South Carolina
Department of Transportation

DM0797

MEMORANDUM TO GROUP LEADERS & CONSULTANTS

SUBJECT: Column Confinement Reinforcing

CONFINEMENT REINFORCING DETAIL AT BEAM-CAP & FOOTING

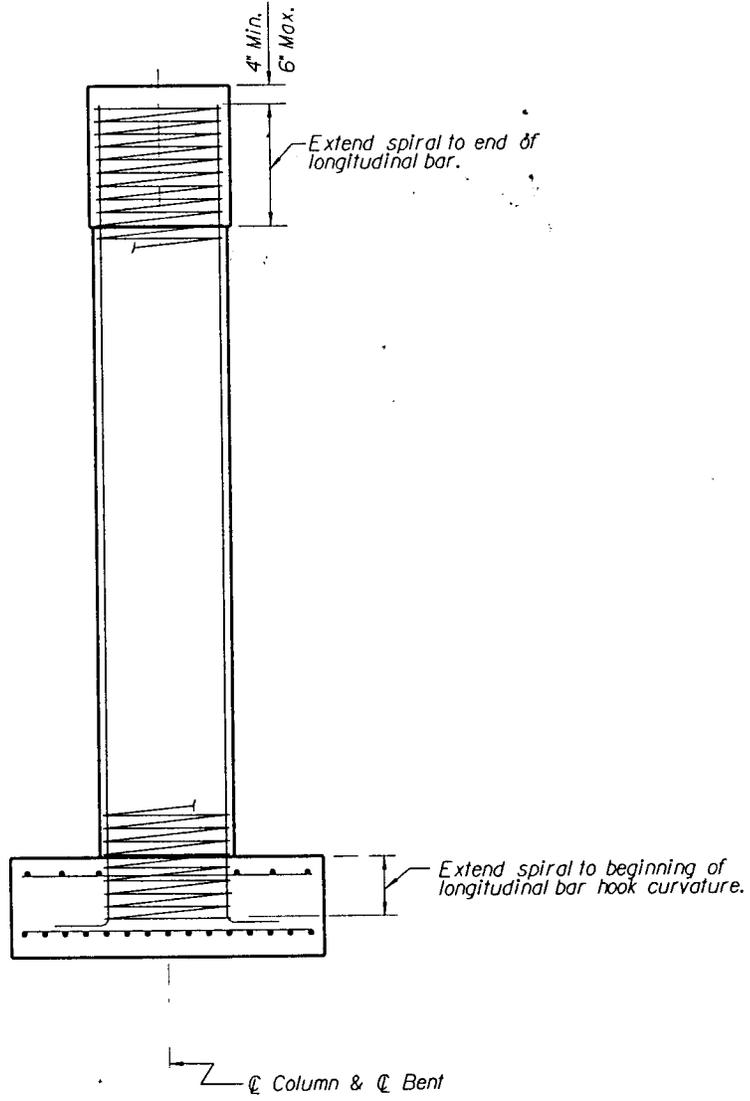
The spirals in columns shall extend into the cap and/or footing as shown on the attachment in the End Elevation.

This memorandum modifies design memorandum DM0391, Figure 4.
